Nomination Form
Anadromous Waters Catalog

Anadromous Waters Catalog Number of Water Body 112-12-10258

Chatham Strait Uncataloged Stream 1

ADDITION

Figure 2.—Falls at waypoint 1545.

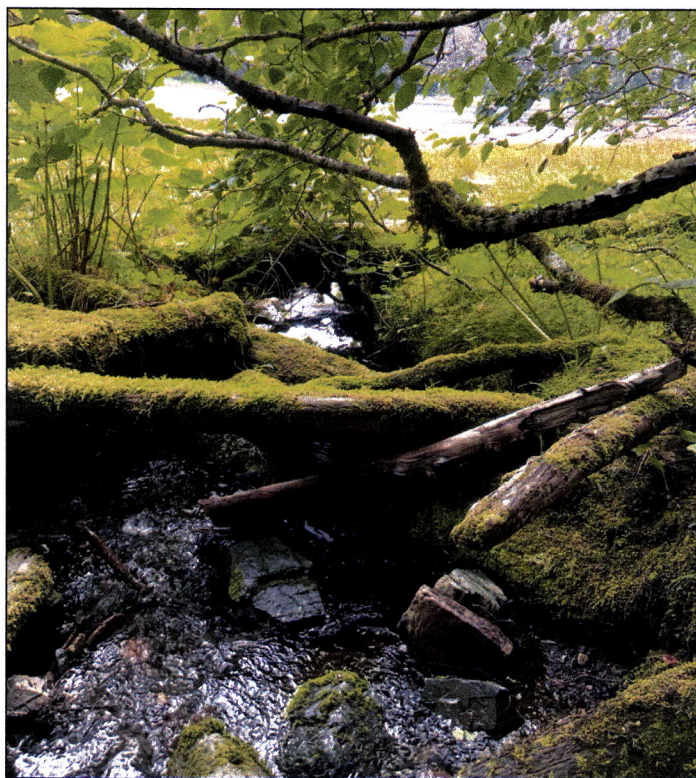
Hey all, got a questions about this nom in Basket Bay. I took the map to indicate the falls/barrier (wpt #1546) was on a different channel and not above the upper point (wpt #1545) we're adding fish up to with the new stream. But then in the comments it seems like maybe there is another barrier or maybe I'm not understanding the hydrography between wpt #1545 and #1546. Can one of you review this and let me know if the Instruction.pdf is correct or did you intend to add the barrier too?

Both of these streams have bedrock falls barriers on them just above the tide line and then tie into each other in the intertidal. We could have done a better job with the notes describing that both are barriers. We leave notes for streams in the vicinity where we did not capture anadromous fish so that someone else use the data. I think you could put a barrier on both streams if you desired, otherwise one on the 1545 waypoint works. Do you want us to include barriers on streams where we didn't capture anadromous fish?

~ADD barrier above new AWC Stream #112-12-10258.
